DOCKETED	
Docket Number:	23-AFC-03
Project Title:	Black Rock Geothermal Project (BRGP)
TN #:	254533
Document Title:	Black Rock Geothermal Project Data Response Set 1 (Revised Response to Data Request 32)
Description:	N/A
Filer:	Lindsey Xayachack
Organization:	Jacobs
Submitter Role:	Applicant Consultant
Submission Date:	2/16/2024 2:04:15 PM
Docketed Date:	2/16/2024

Data Response Set 1 (Revised Response to Data Request 32)

**Black Rock Geothermal Project
(23-AFC-03)
February 5, 2024**

ADDENDUM TO THE CULTURAL RESOURCE TECHNICAL REPORT FOR THE BLACK ROCK GEOTHERMAL PROJECT, IMPERIAL COUNTY, CALIFORNIA

Figure 1-2. Project location and survey coverage map.

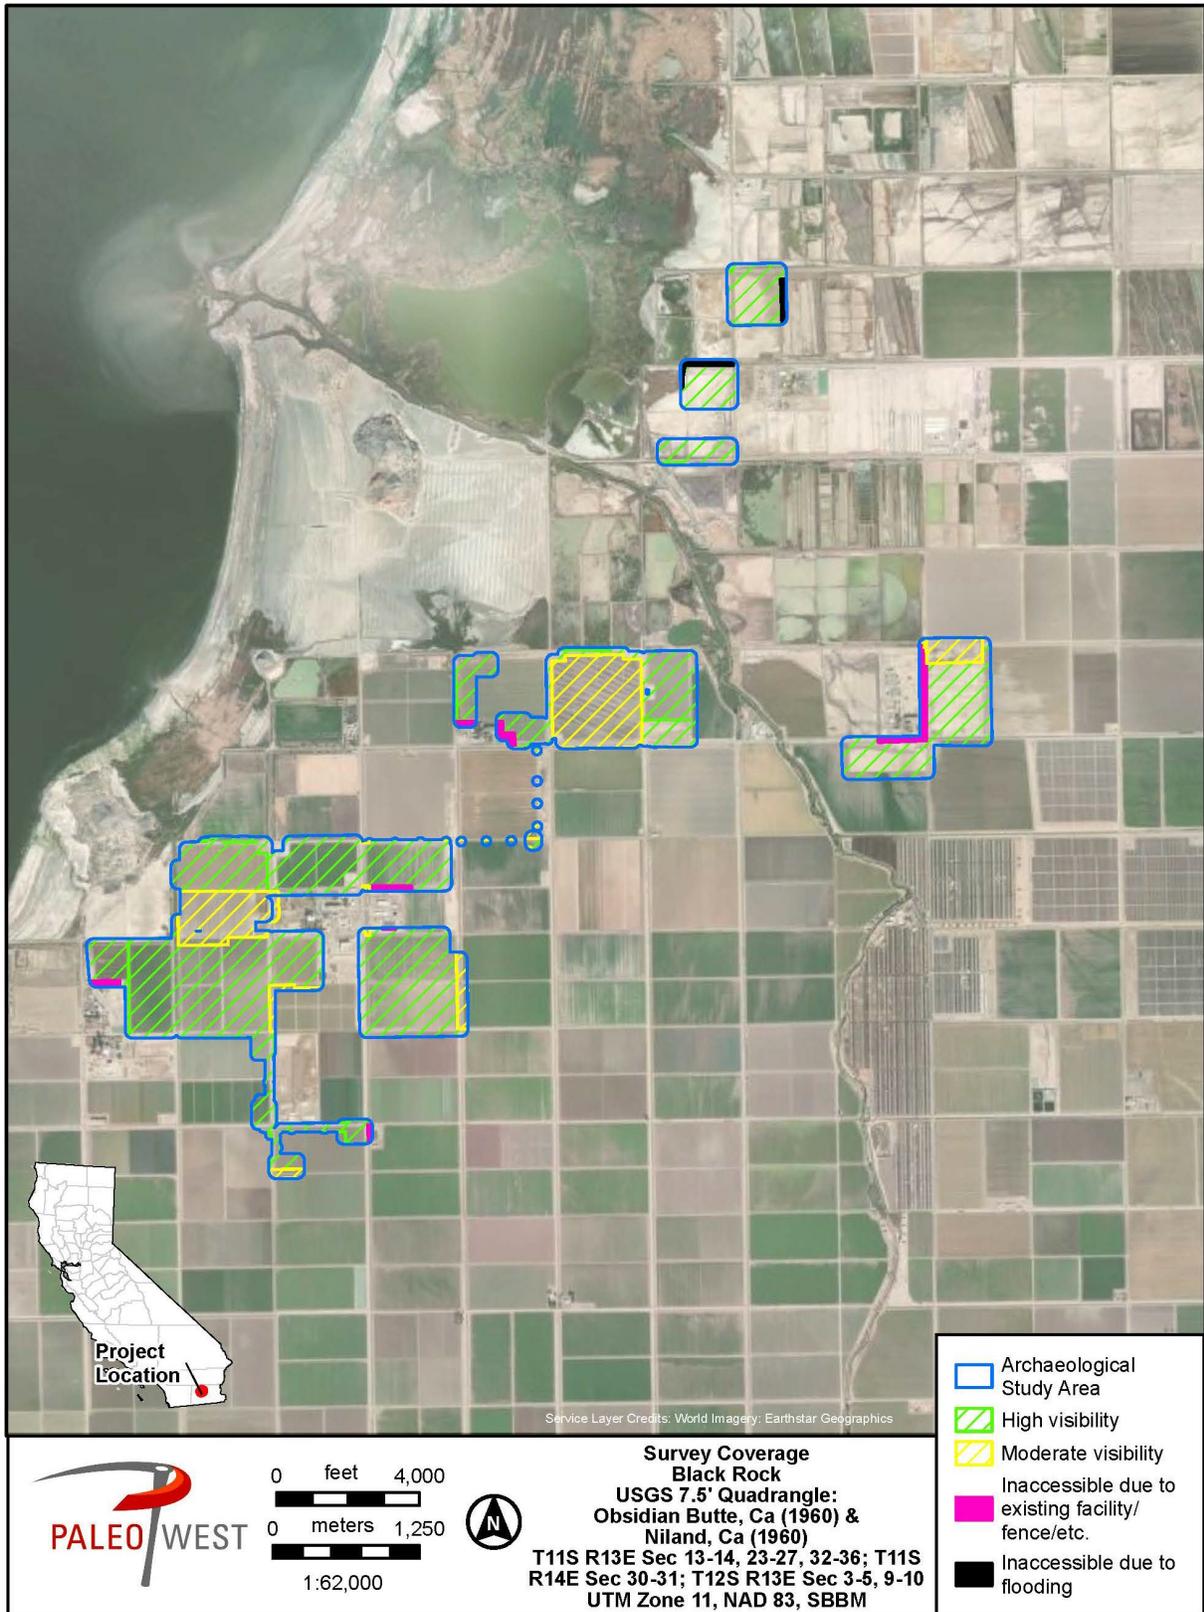
32. Please indicate when the Bermuda grass and other crops will be harvested from the low-visibility portions of the archaeological study area?

Response: The Applicant has resurveyed some areas that were previously identified as low visibility; however, areas previously obstructed by standing water remained underwater during each resurvey attempt. No new archaeological sites or isolated finds were identified. A copy of the Addendum to the Cultural Resource Technical Report for the Black Rock Geothermal Project is provided as Attachment DRR 32.

The supplemental archaeological study area is composed of agricultural fields, human-made ponds, a riparian landscape adjacent to the Alamo River, and mud flats (Figure 1-2). The topography is flat except for human made canals and berms. Soils were fine- to medium-grained alluvial sandy loam that are light tan in color and composed of quartz and granitic material. Due to the extensive agricultural and geothermal development in this portion of the valley, little natural vegetation was observed in the archaeological study area.

Ground visibility across the supplemental archaeological survey area varied from excellent visibility (close to 100%) to moderate visibility (25–75%). Except for 31.3 acres of land that consisted of existing geothermal facilities and 4.3 acres of land that were inaccessible due to standing water, the entire supplemental survey area was inventoried for archaeological resources. PaleoWest did not have permission to enter existing geothermal facilities; however, archaeologists were able to examine each of these areas from the perimeter fences and confirmed that the areas had been extensively disturbed by the development of the geothermal facilities.

As part of the supplemental survey, PaleoWest revisited each of the areas that was previously inaccessible due to standing water between September 12–14, November 14–16, and December 12, 2023. During all three revisits, PaleoWest archaeologists found the areas were flooded with standing water. Given that over the course of one year, the areas were consistently underwater, additional attempts to resurvey of these areas are not recommended.

No archaeological resources were identified in the supplemental archaeological survey area.
